Interactive comment on “Joint retrieval of surface reflectance and aerosol properties with continuous variation of the state variables in the solution space: Part 2: Application to geostationary and polar orbiting satellite observations” by Marta Luffarelli and Yves Govaerts

Marta Luffarelli and Yves Govaerts

Received and published: 5 October 2018

Fig. 1. Merged Figure 6

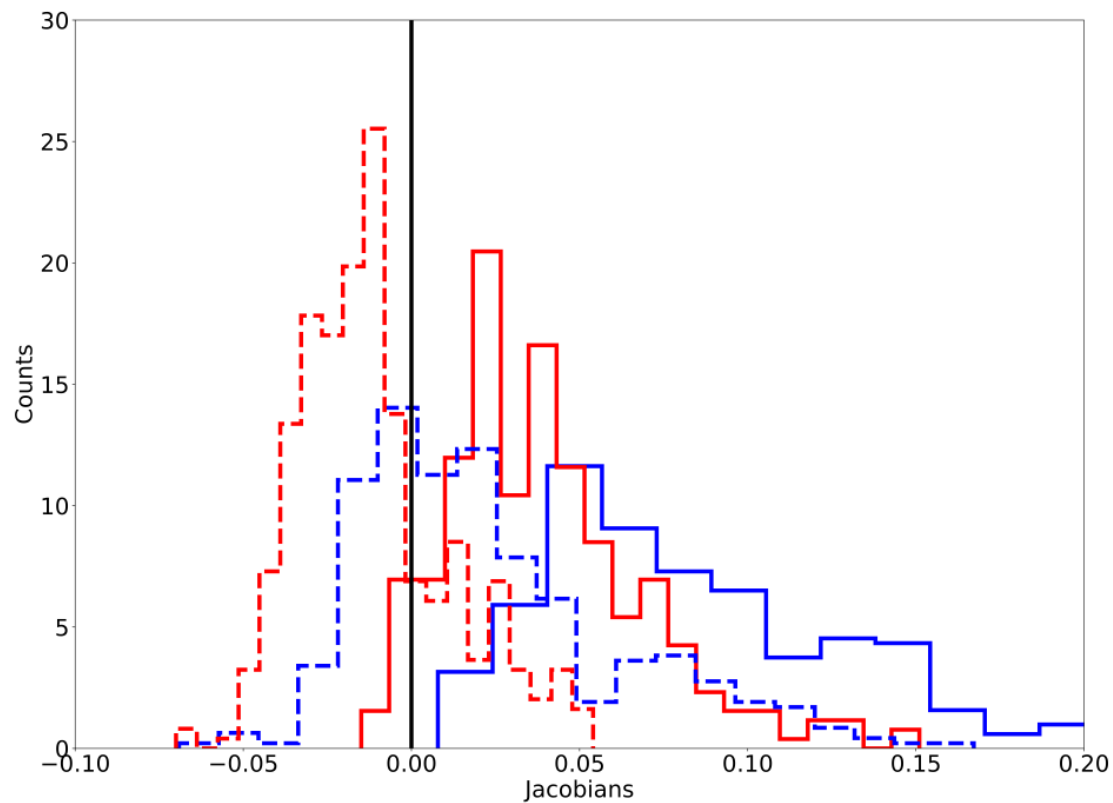
5. Fig 6. : merge the two panels into one, since you compare Carpentras with Zinder.

The merged figure looks quite confusing (Fig. 1). Even changing colors and line styles it would still not be very easy to understand. Keeping the separate panels appears a better choice.

Fig. 2. Bias between CISAR retrieved AOT from SEVIRI (blue) and PROBA-V (red) and AERONET data. The histograms show the distribution of the AERONET data.

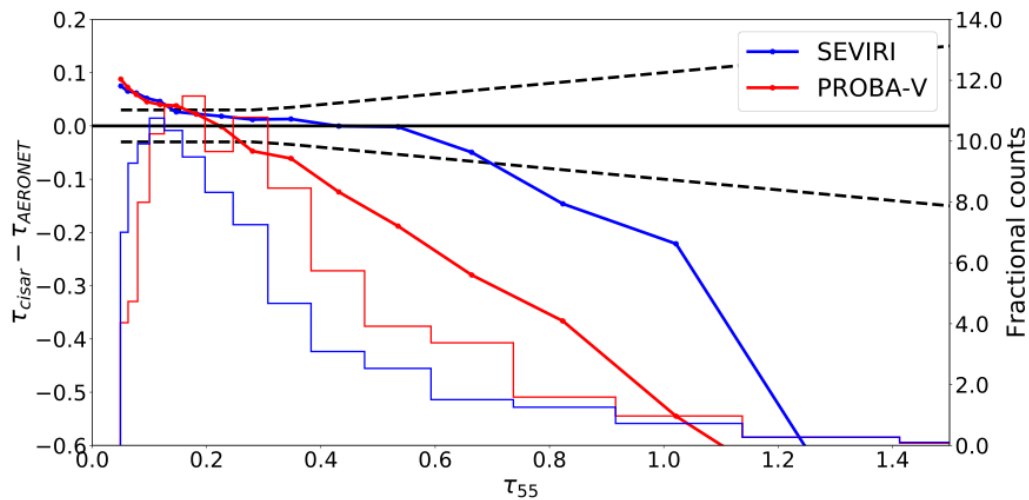
15. Line 456-459. This is one of my most important comments. After the manuscript goes to a great length in describing a very elaborate way to aid the retrievals with "tests", the results presented in Fig. 14 are clearly not satisfactory (a look at the correlation coefficients immediately tells that the algorithm is not retrieving appropriate AOTs). Then it is commented that at high AOTs the algorithm might fail (then why all the tests?), but that's not too worrisome since it is better if it performs accurately at low optical depths, which are more typical. I might agree with that, but then I have to ask 1) how do you deal with the fact that the 1:1 correlation is as poor at low optical depths; and 2) why the only AOT used for testing was 0.4 in part 1.

The bias between the CISAR retrieval and the AERONET data is shown in Fig. 2, which shows different performances for SEVIRI and PROBA-V. These differences show that

the bias does not only depend on the CISAR algorithm itself, but also on the quality of the processed data. The green histogram shows the AERONET AOT distribution for each bin associated with the CISAR applied SEVIRI AOT product. It can be seen there only few points correspond to $AOT > 0.8$ (less than 5% of the total number of observations), affecting the reliability of the statistics for high values of AOT. The histograms have been added in Fig. 14.

The CISAR AOT product shows overestimation at low AOT and underestimation at large AOT values. The overestimation rapidly decreases as the AOT approaches values of about 0.2. The retrieval is within the GCOS requirement (dashed lines) for $0.2 < AOT < 0.75$. For SEVIRI, two factors might explain the overestimation of the retrieved AOT below 0.2. Firstly, most of the selected AERONET stations are located in Europe as can be seen on Fig. 1 of the revised paper, where the SEVIRI pixel resolution is about 5×8 km (as opposed to 3×3 km at the subsatellite point) which is compared to AERONET point measurement. The probability of residual cloud contamination at this scale might thus explain part of the overestimation (Henderson and Chylek 2005, <https://ieeexplore.ieee.org/document/1499014/authors#authors>). Secondly (and most likely explanation), it should be reminded here that SEVIRI shortest spectral band is 0.67. At low optical thickness, e.g., 0.1, the sensitivity to aerosol at 0.67 is about 2 times smaller than in the blue spectral regions and 1.5 smaller than in the red. A preliminary analysis revealed that the sensitivity of the TOA BRF to an increase of the AOT from 0.05 to 0.15 is responsible over dark surface to a change comparable with the magnitude of the radiometric uncertainty in the $0.67 \mu\text{m}$ band. Consequently, the retrieval in these cases essentially relies on the prior information despite the very large associated uncertainty (1.0 for the fine mode, 2.0 for the coarse mode). The prior AOT magnitude is taken from the climatology proposed by Kinne et al., 2013 (doi:10.1002/jame.20035.), which exhibit typical mean values around 0.12 in the SEVIRI disk.

Fig. 3. BHR timeseries at 0.6 μ m over Carpentras

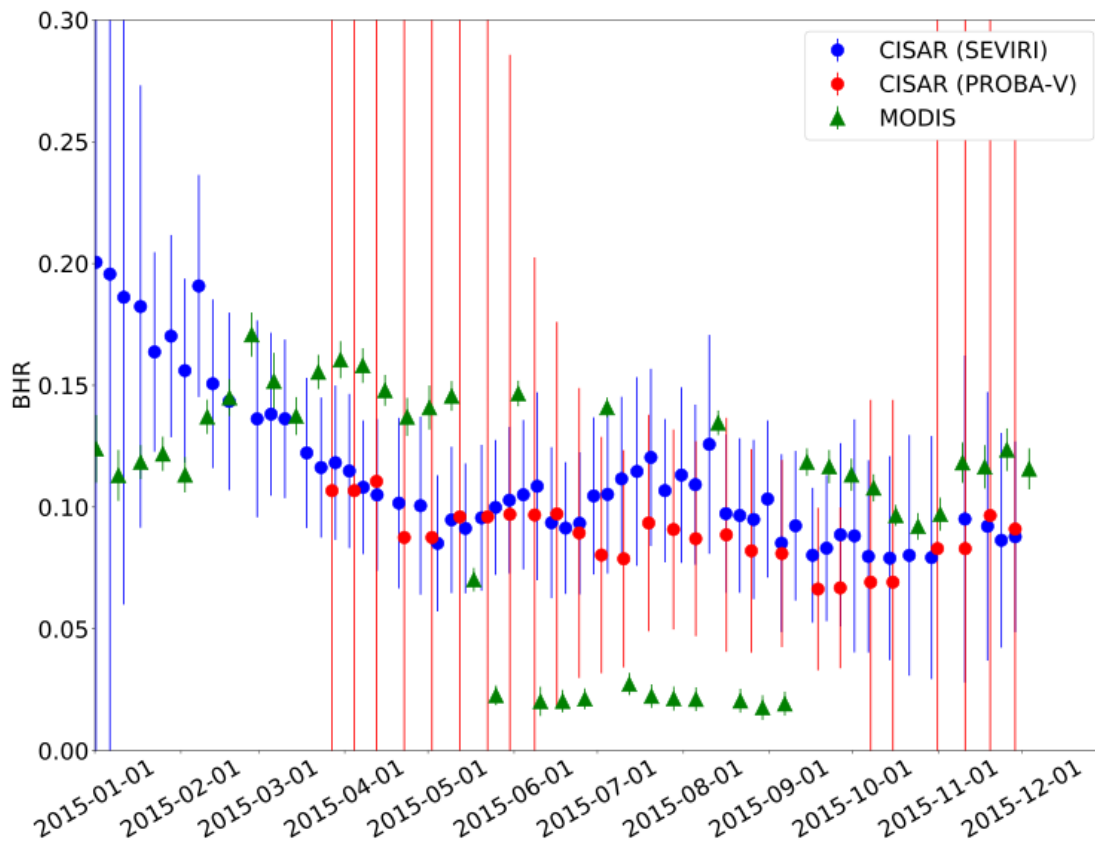
19. Sec. 6.3: how about Carpentras?

The timeseries is shown in Fig. 3 where the MODIS data have been filtered according to their associated quality flag (https://lpdaac.usgs.gov/sites/default/files/public/modis/docs/MODIS_LP_BRDF+Albedo_QA_Tutorial-4.pdf). It can be seen that the MODIS timeseries shows some issues and cannot be considered reliable. This might also partially explain the scattering in the BHR density plots in the supplements. Using MODIS to simulate satellite observations in the attempt of proving the FASTRE capability of correctly characterise the satellite observations we underestimated the effort to collect ground truth RPV parameters.
